REGDOC-2.2.1
CNSC Human Performance:
Managing Worker Fatigue
and Hours of Work

Review and Public Comment Submitted by EDP Software

January 17<sup>th</sup>, 2014

Table 3 - Counting of continuous working shifts for recovery periods

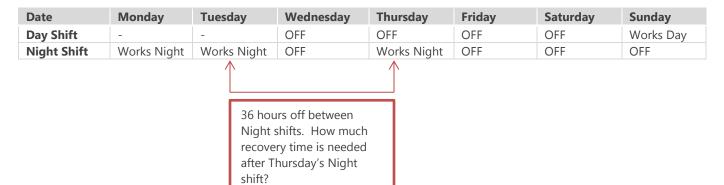
Counting using the term 'Continuous shifts'

- Monday and Tuesday night shifts are continuous. The rules state that 48 hours off is required.
- Thursday's night shift occurs after only 36 hours.
- Does this count as 3 continuous night shifts and therefore requires 72 hours off after Thursday's night shift?
- Does this count as 2 continuous night shifts and a violation because there was only 36 hours off? If
  this case is true, does the violation go away if we were to add a shift on Wednesday night and make
  it 4 continuous nights? Adding work to the schedule should not cause a fatigue violation to go
  away.

Counting using the concept of 'Work Sets'

- Monday and Tuesday shifts are back to back. Part of the same work set. 2 night shifts means that a 48 hour break is required.
- Thursday night shift only provides a 36 hour break. Adequate recovery is not given and therefore Thursday's night shift is part of the work set and that means there are now 3 night shifts in the set.
- Sunday Day shift only provides 60 hours of break. A 72 hour break is required and therefore adequate rest is not provided. There are 2 ways this can be interpreted:
  - Sunday Day shift is included in the work set. At that point there will be 4 shifts in the set.
     Employee could work 1 more shift until they hit 5 shifts in the set and then MUST have the 72 hour break.
  - Enforce that the required break must occur before moving between shifts. This
    interpretation is helpful for fatigue as it forces breaks when moving from Day shift to Night
